Access Compliance Report

Public Rights-of-Way

(Curb Ramps)

Intersection ID: 10276	Main Street: ASHLEY_RD	Cross Street: TUCKASEEGEE_RD	Location: SE
ADA ID: 1FF0C6DFE1B9	Ramp Type: Perp	Initial Pass/Fail: Fail	Overall Compliance: No
		Severity Score: 10

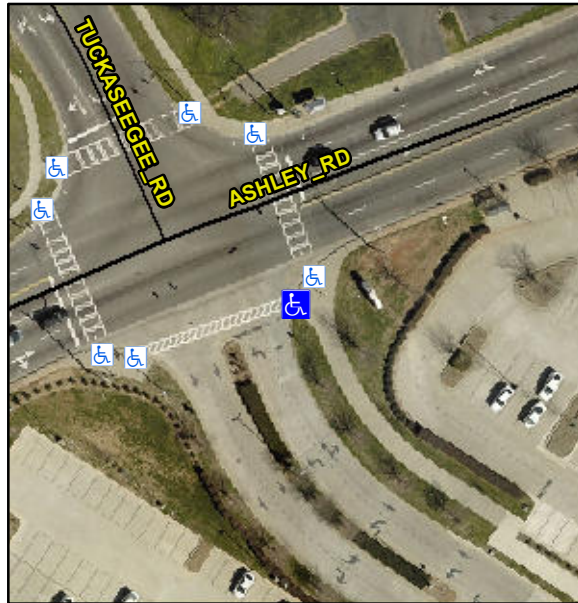
R304.5.1, R304.5.3

Compliance	Description	Data	Compliance	Description	Data
N/A	Ramp Length (in)	84.0	Yes	Ramp Slope (%)	5.7
No	Ramp Width (in)	47.5	No	Ramp XSlope (%)	3.4
N/A	Flare Type LT	N/A	N/A	Flare Type RT	N/A
N/A	Flare Slope LT (%)	N/A	N/A	Flare Slope RT (%)	N/A
N/A	Flare Traversable LT?	N/A	N/A	Flare Traversable RT?	N/A
N/A	Landing Length (in)	N/A	N/A	DWS Provided?	N/A
N/A	Landing Width (in)	N/A	N/A	DWS Contrast?	N/A
N/A	Landing Slope (%)	N/A	N/A	DWS Length (in)	N/A
N/A	Landing X Slope (%)	N/A	N/A	DWS Full Width?	N/A
N/A	Landing Curb? (Y/N)	N/A	N/A	DWS Offset (in)	N/A
N/A	Shared Landing?	N/A			
N/A	Gutter Ponding?	N/A	N/A	Gutter Slope (%)	N/A
N/A	Gutter Lip Ht (in)	N/A	N/A	Gutter X Slope (%)	N/A
N/A	Painted X Walk1?	Yes	N/A	Painted X Walk2?	N/A
	X Walk 1 Direction	To W		X Walk 2 Direction	N/A
N/A	X Walk 1 Width (in)	51.0	N/A	X Walk 2 Width (in)	N/A
	X Walk 1 Slope (%)	2.2		X Walk 2 Slope (%)	N/A
	X Walk 1 X Slope (%)	0.7		X Walk 2 X Slope (%)	N/A

Remove & Replace Entire Ramp.
